MWO 9-1005-319-20-1

MODIFICATION WORK ORDER

**MODIFICATION OF
CARBINE, 5.56MM,
M4 (NSN 1005-01-231-0973)
M4A1 (NSN 1005-01-382-0953)**

30 Nov 2006

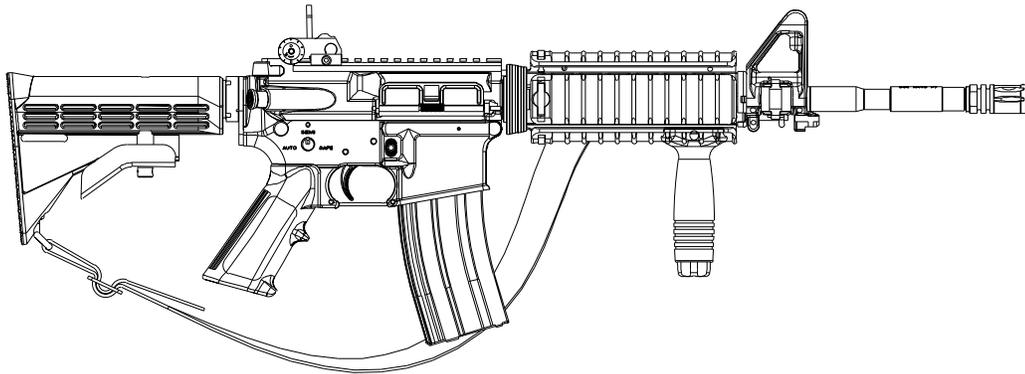
15. MODIFICATION IDENTIFICATION. Visual verification of application can be made as shown in illustration.
